RICHMOND COMMUNITY SCHOOL
Richmond High School: Mechanical Modernization Project
LWC Commission No. 20104.02

ADDENDUM #04
October 5, 2021

| TOD | A103 |

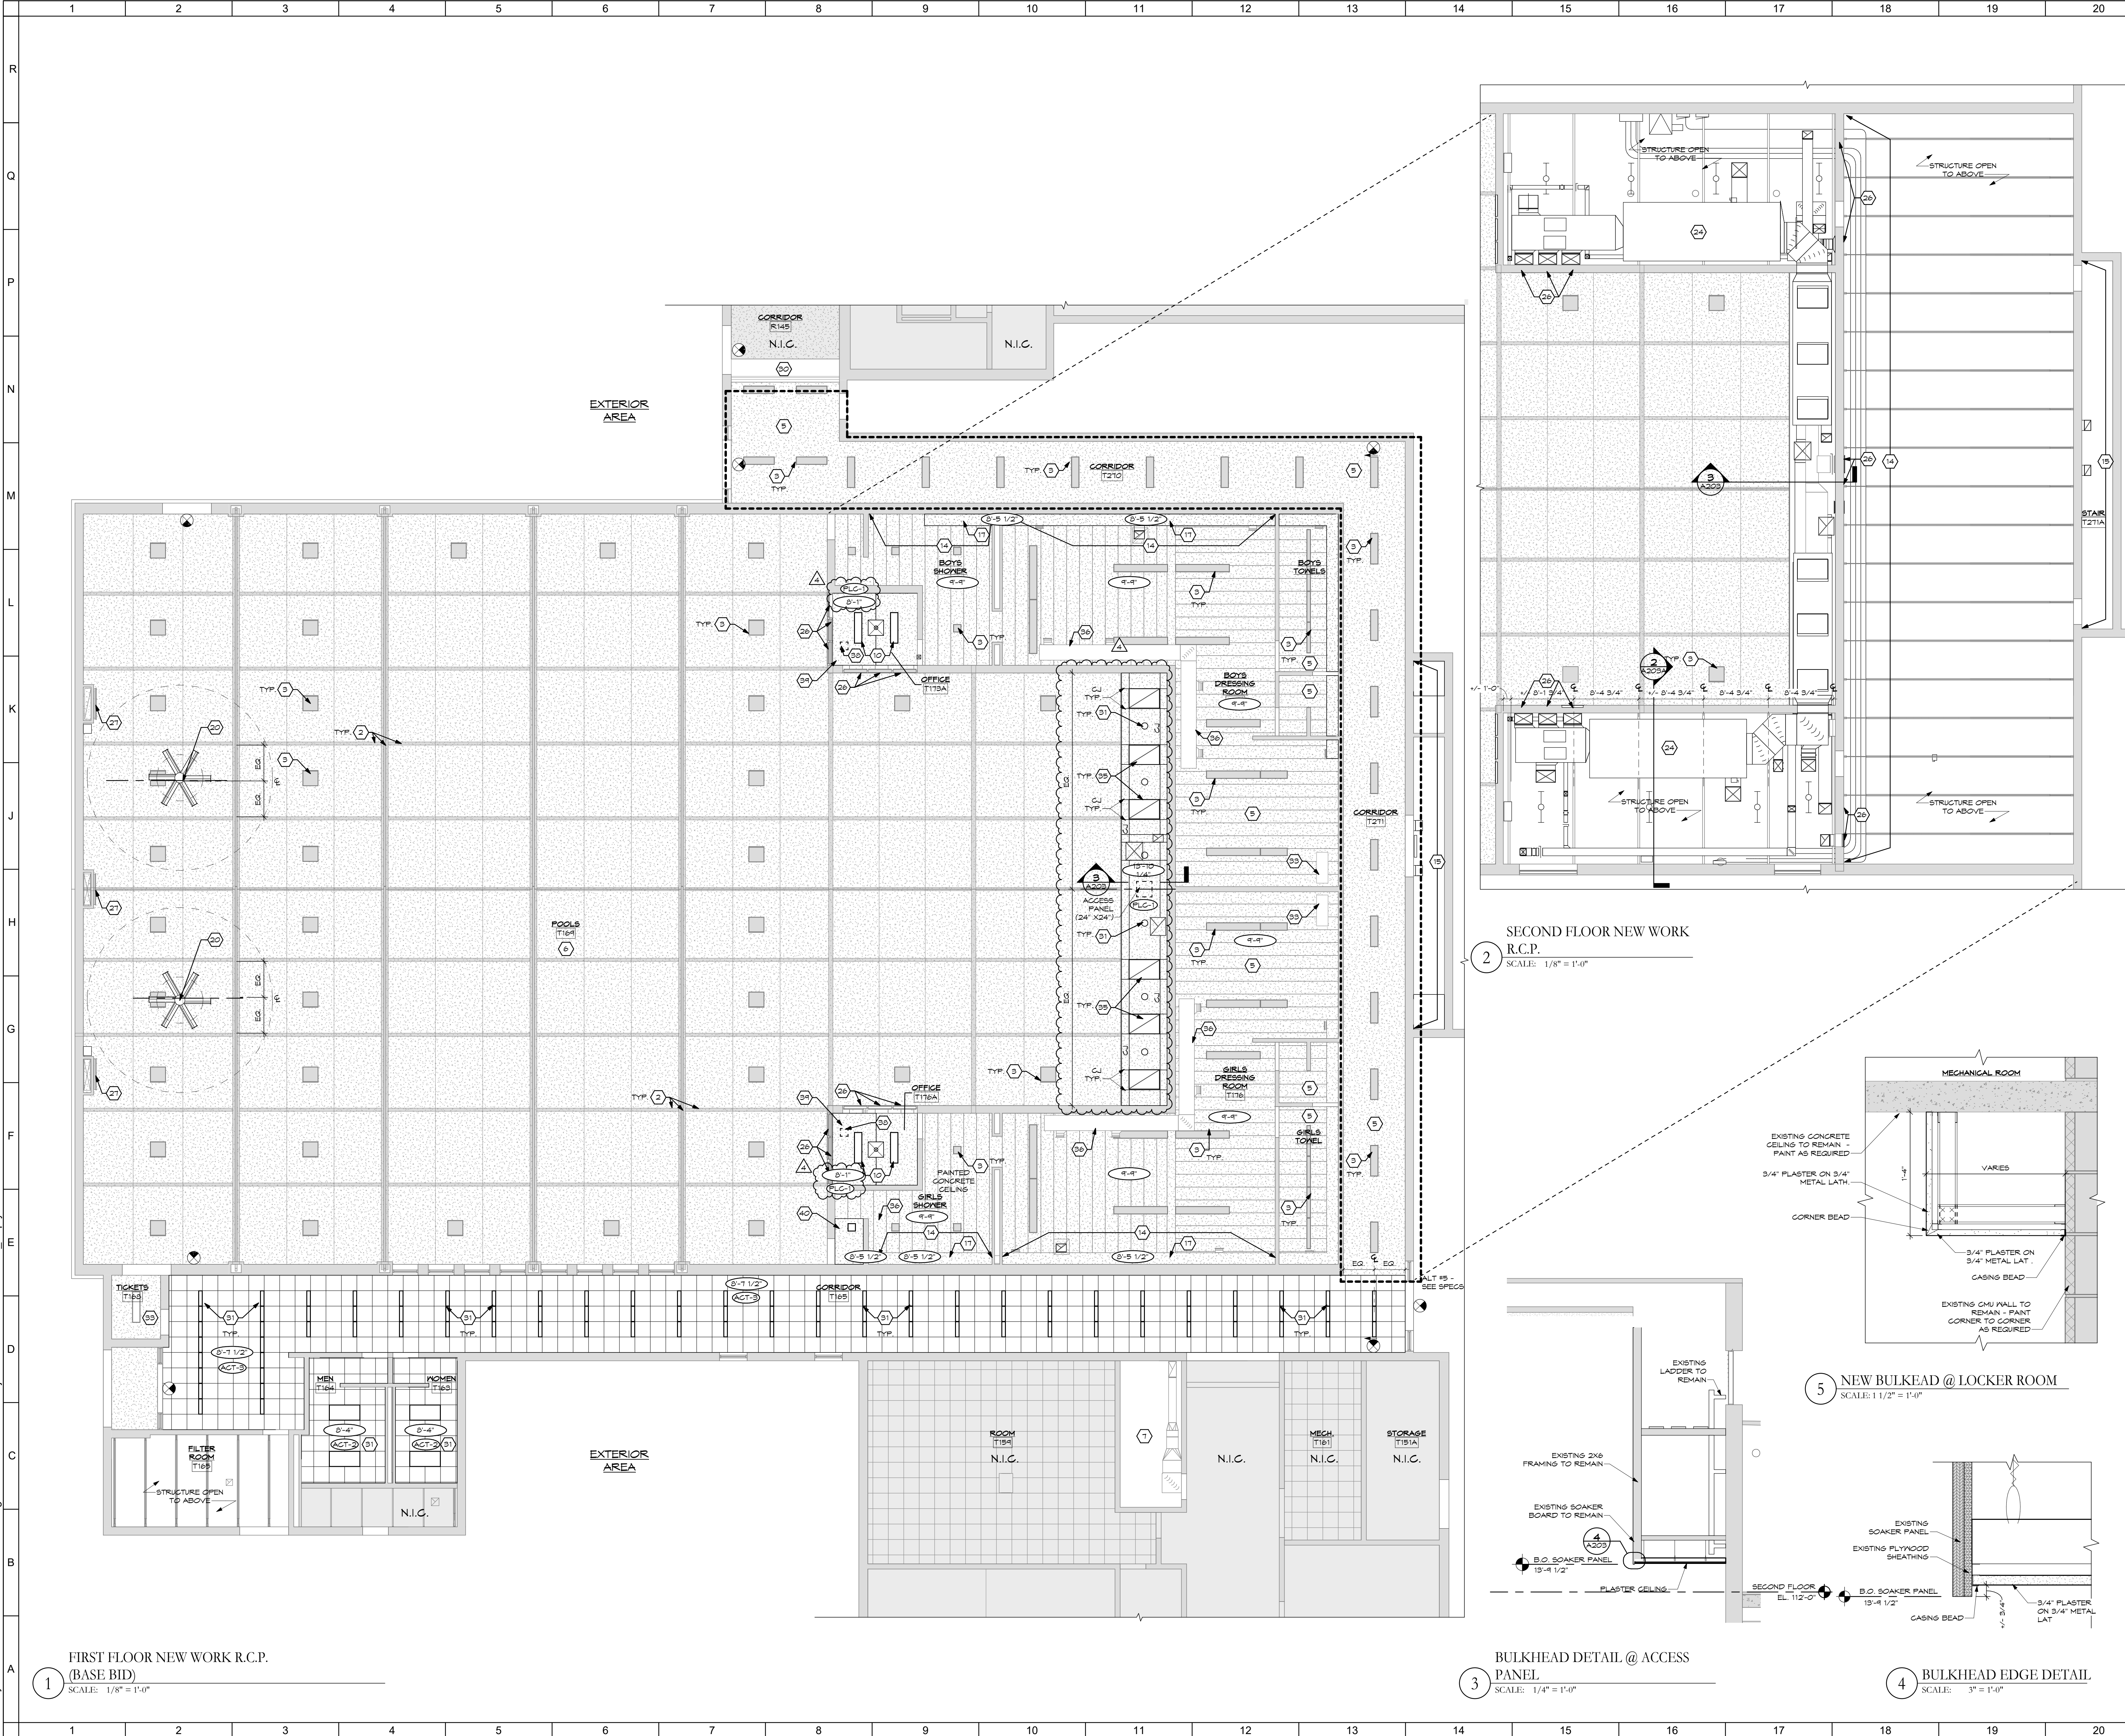
ITEM NO.2 Drawing A103

- A. Revised finished schedule.

| RFI Number | Date IN | Date OUT | Due Date | Description/Response | Sheet/Spec Reference | PCO Number | CO Number |
|--------------------------|---------|----------|----------|---|----------------------|------------|-----------|
| Whisenhunt 002 | 10/1/21 | 10/5/21 | | 3/A203 shows an ACT ceiling...however, ACT 4 in the finish schedule(A103) lists Plaster Ceiling as the finish. | | | |

| Drawn | TOD | Drawing No. | A203 |

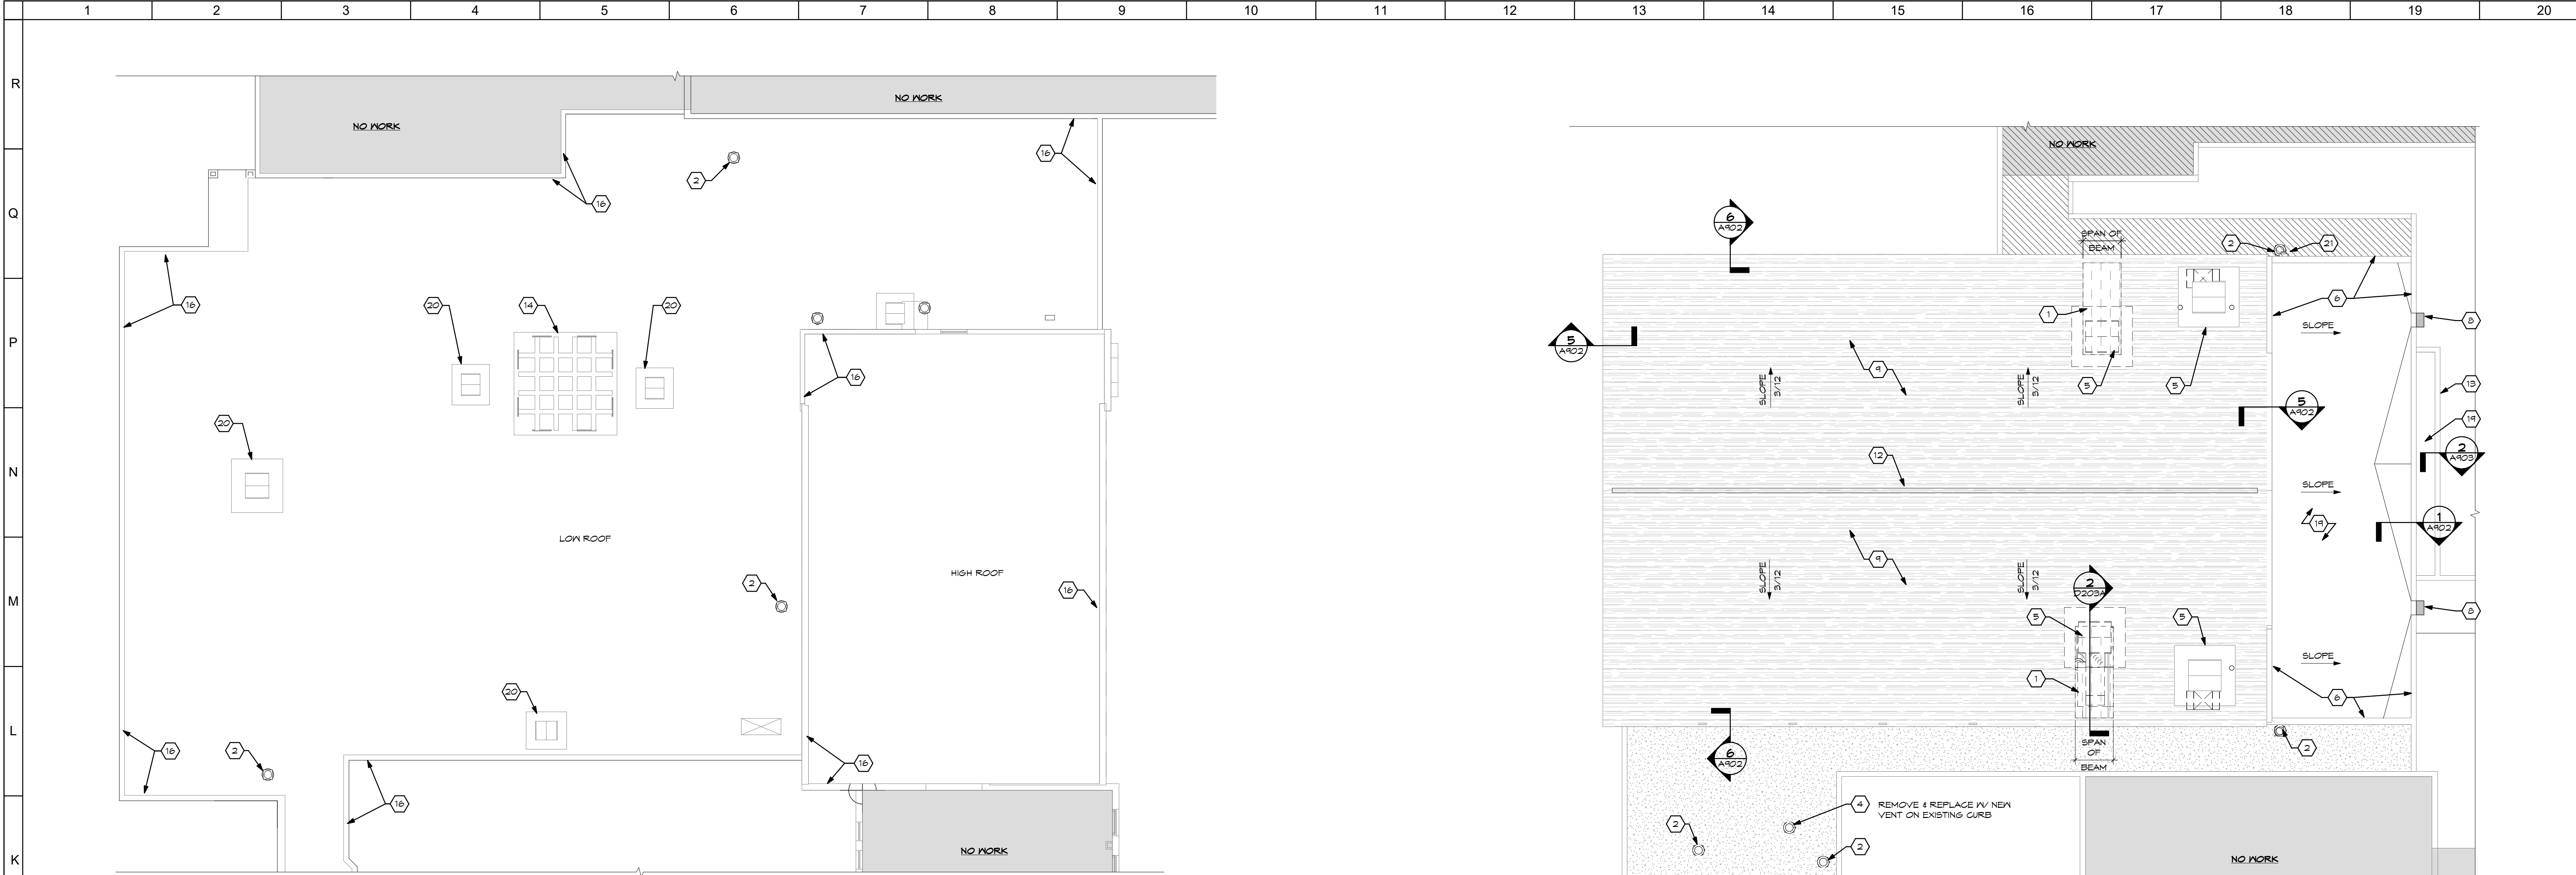
ITEM NO.3 Drawing A203

- A. Revised Finish Tag at ceilings

| RFI Number | Date IN | Date OUT | Due Date | Description/Response | Sheet/Spec Reference | PCO Number | CO Number |
|--------------------------|---------|----------|----------|---|----------------------|------------|-----------|
| | | | | ANSWER: The ceiling in Detail 3/A203 is intended to be plaster. The drawings have been revised to clarify this intent. | | | |
